TOWN OF YORKTOWN PLANNING BOARD

PUBLIC MEETING AGENDA VIDEO CONFERENCE

June 28, 2021

**PLANTING
 PLAN**

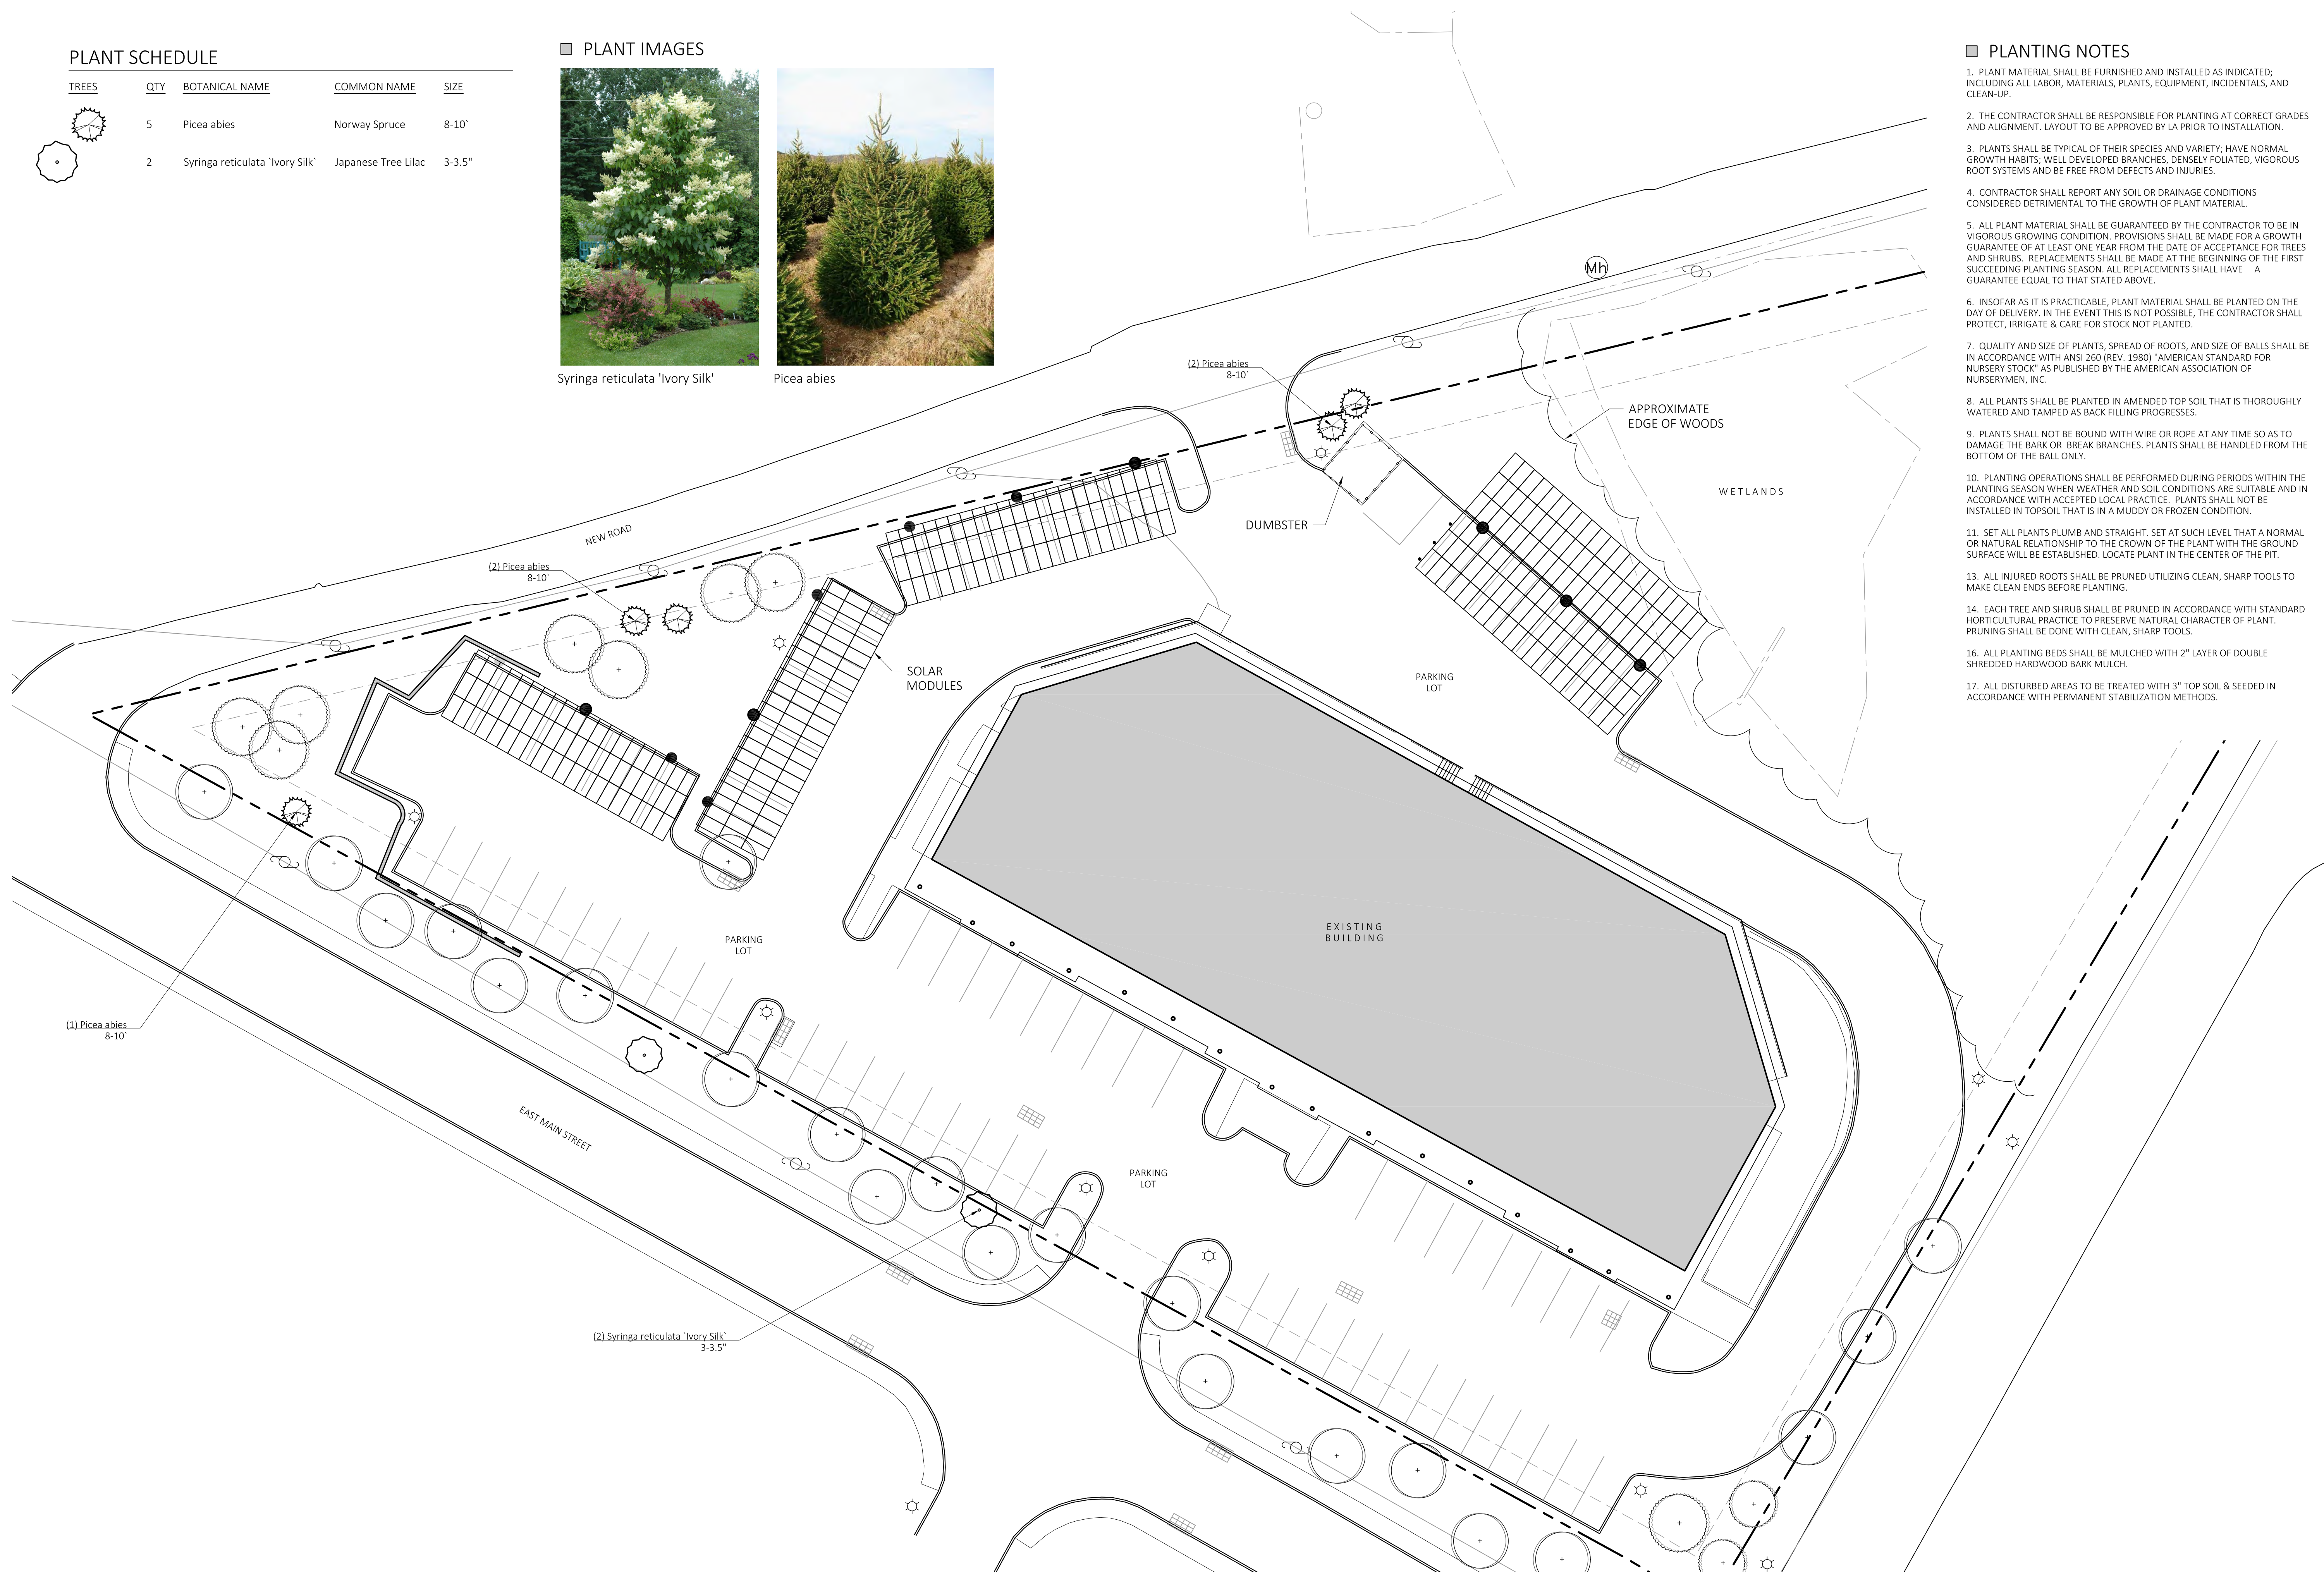
Planting of two (2) Japanese Lilac trees is not recommended as these are non-native trees. Note that the mitigation section of Chapter 270 requires planting of native species [see §270-10.C.(4)]. We recommend planting Dogwood or Service Berry trees.

CANOPY #4 - ELEVATION
 N.T.S.

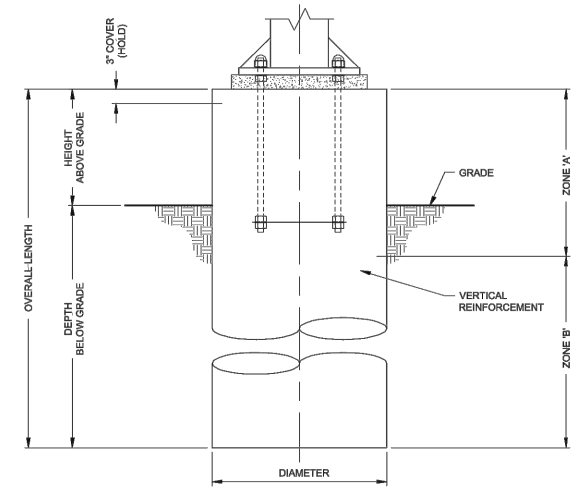
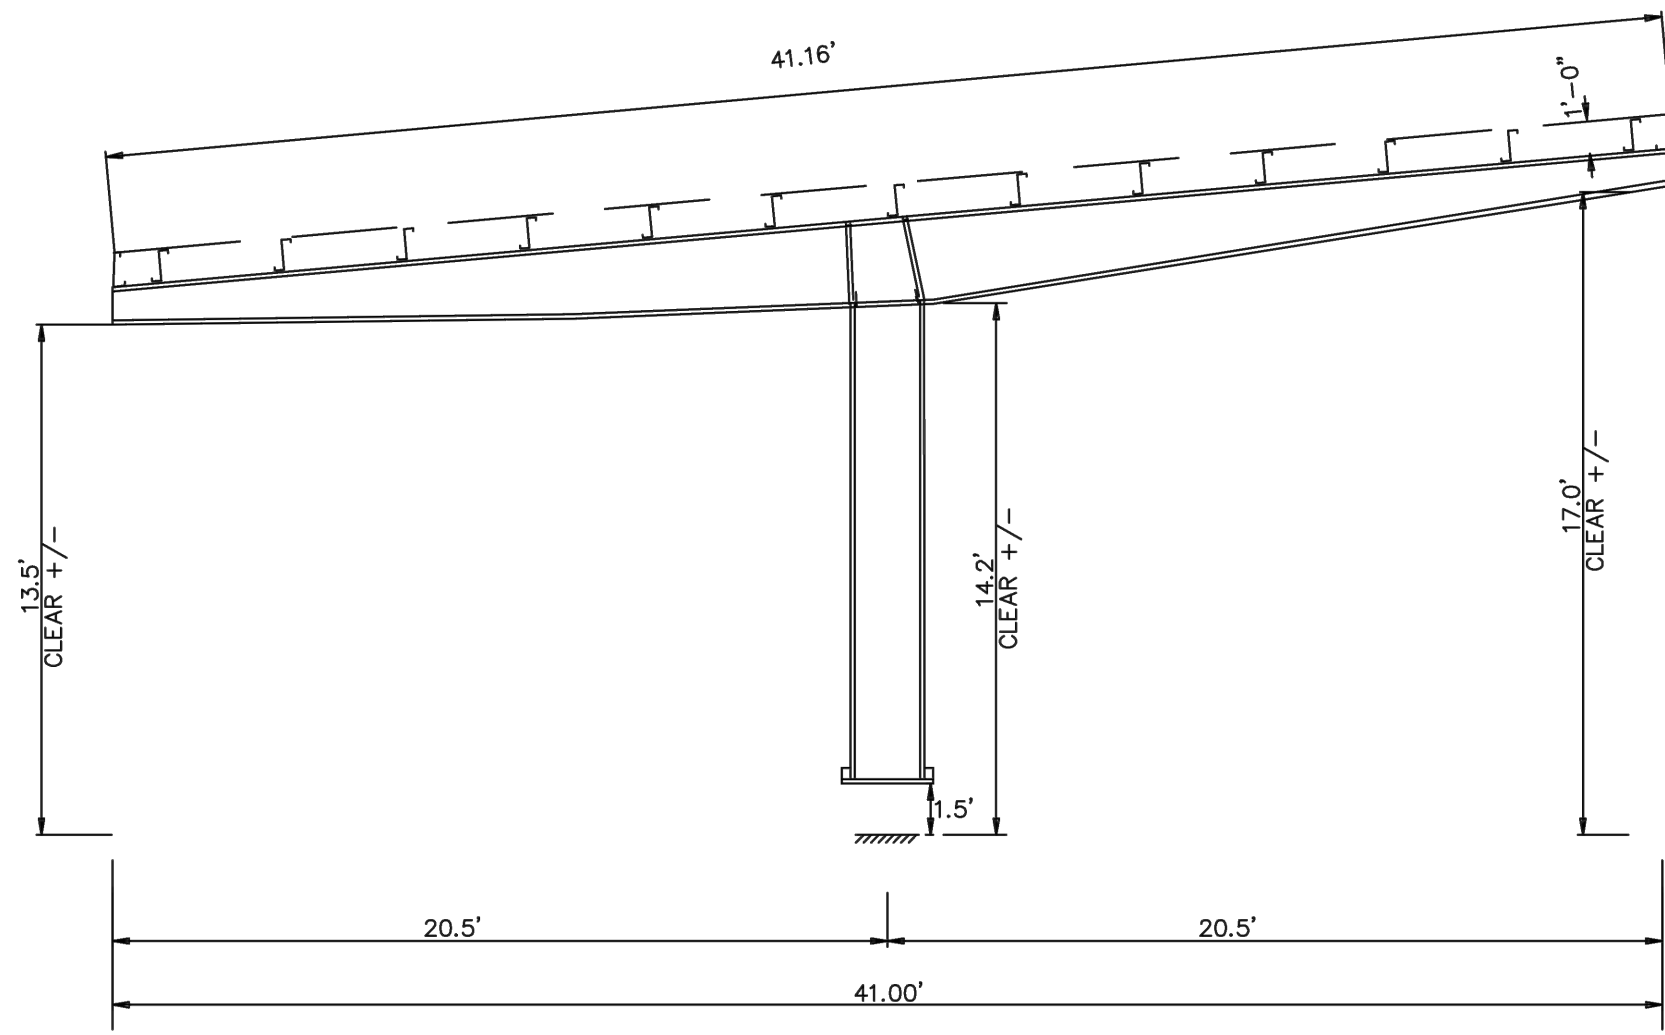
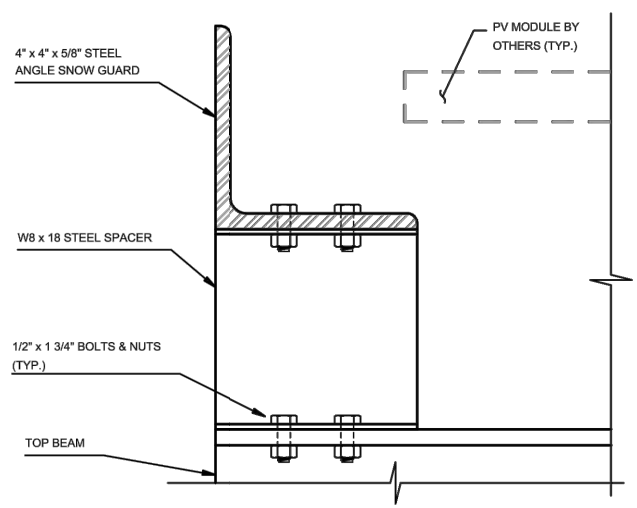
- Canopy structure 4 support in the rear of the property appears to be in the wetland. The Board recommends this canopy be adjusted so the support is out of the wetland so there will be no disturbance to the wetland.
- Although this site is disturbed and developed, all the work of the project is in the wetland buffer. The Board requests mitigation for intrusion into buffer. Mitigation should improve the function of the wetland.
- The Board requests additional screening be provided around the transformer box.
- Project will remove approximately 10 trees. Tree permit and mitigation is required.
- The Conservation Board reviewed the planting plan and is satisfied to see non - invasive plant material being used.
- A joint site visit will be planned with the Planning Board when additional comments will be made.

The Board requested that Ecogy provide more detail about the disturbance created by the foundations of each canopy structure, particularly the footings for Canopy #4 within the unpaved surface near the wetlands on the property.

Ecogy Response: The majority of the disturbance created during construction will be contained within the paved parking areas, with the exception of one underground trench and the foundations for Canopy #4. The foundations for Canopy #4 have been sited outside of the paved area to avoid conflict between the spacing between support columns and the existing parking lot spaces. Ecogy's engineering team has calculated the disturbance to be as follows for the canopy foundations and trenching for underground electric lines between the canopies: 650 square feet of paved asphalt surface area and 200 square feet of unpaved/grassy areas will be disturbed during construction of the parking lot canopies.
